Summary of the response letter in the stage of technical corrections

Mapping Three Decades of Urban Growth in China: A 30 m Annual Building Height Dataset (1990 – 2019)

Figure 1. Updated Fig. 2 in the revised manuscript.

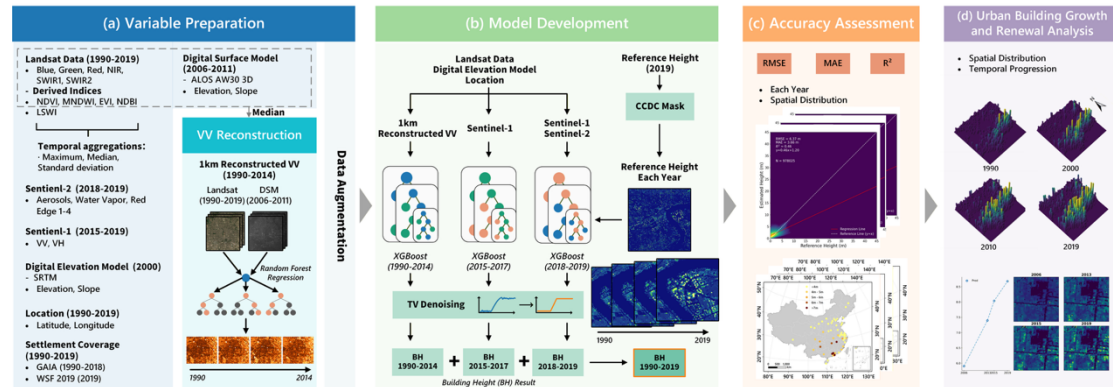
10. The term “urban growth” is not rigorous, as urban areas include many land cover types beyond buildings. Suggest "urban building growth."

Thank you for this helpful suggestion. We agree that the terminology should better reflect the actual content of the study. Accordingly, “urban growth” is revised to “urban building growth” to more precisely describe the focus on building-level dynamics rather than general urban land-cover expansion.

Text in Section (d) of Fig. 2 is also changed accordingly to “Urban Building Growth and Renewal Analysis”.

Figure 2. Updated Fig. 7 of the revised manuscript.

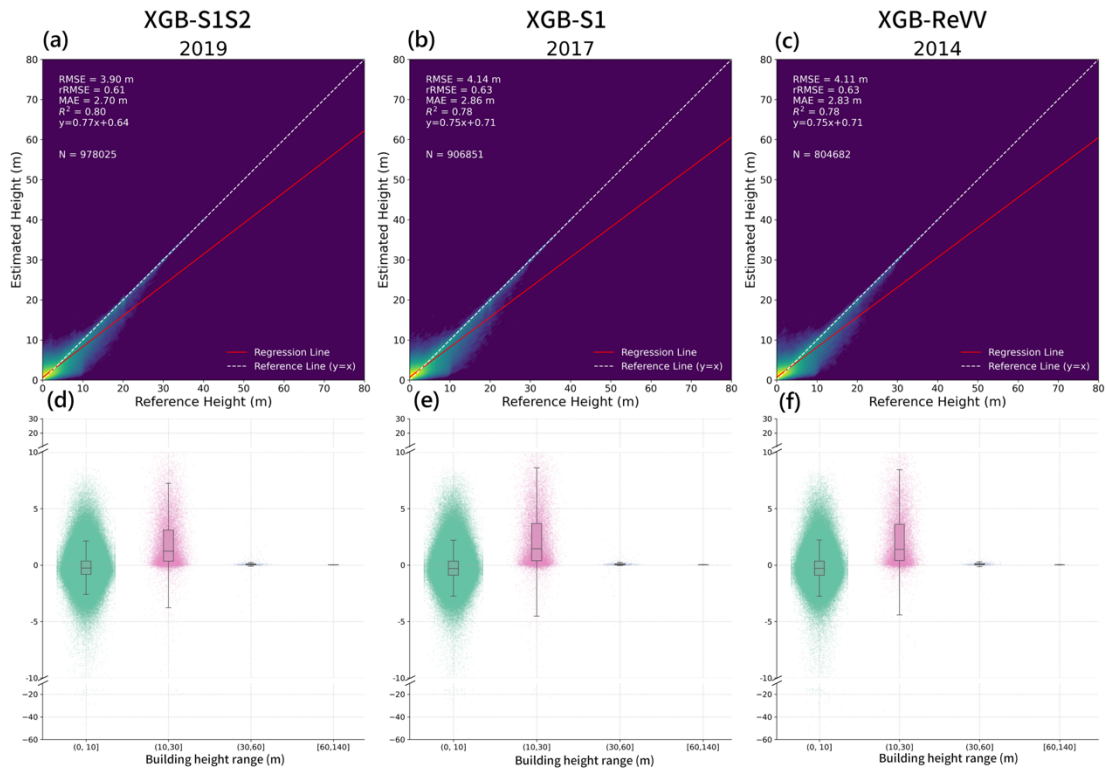
12. Unify the relevant nouns in text and figures. The manuscript uses “building heights” while Figure 7 uses “built-up height”.

We sincerely thank the reviewer for catching this inconsistency. We have corrected "built-up height" to "building height" in Fig. 7 to match the terminology used throughout the manuscript.

Figure 3. Updated Fig. 15 of the revised manuscript.

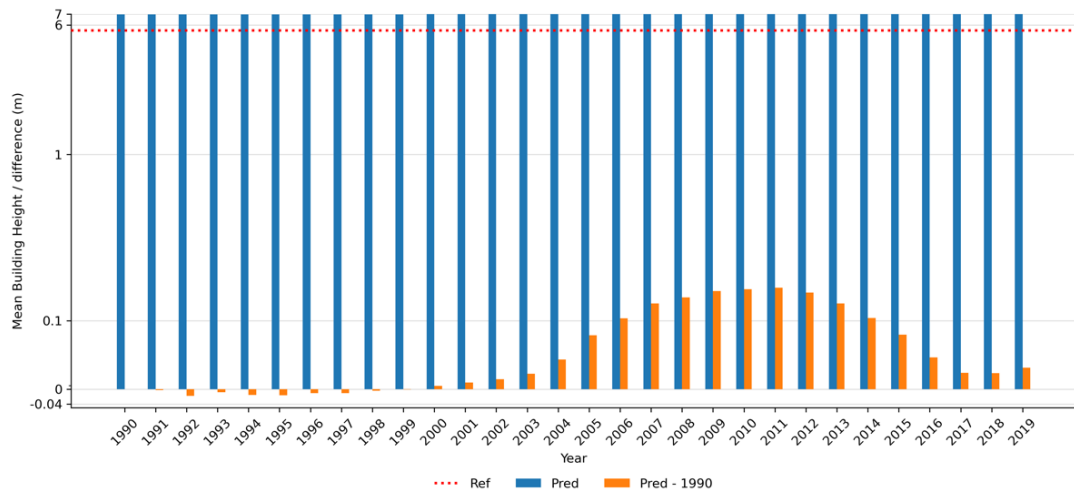
14. Figure 11: the year order seems odd—consider reversing it.

Thank you for this suggestion. We carefully reviewed Fig. 11 in the original manuscript (Fig. 15 in the revised manuscript) and confirmed that the years are presented in the correct order.
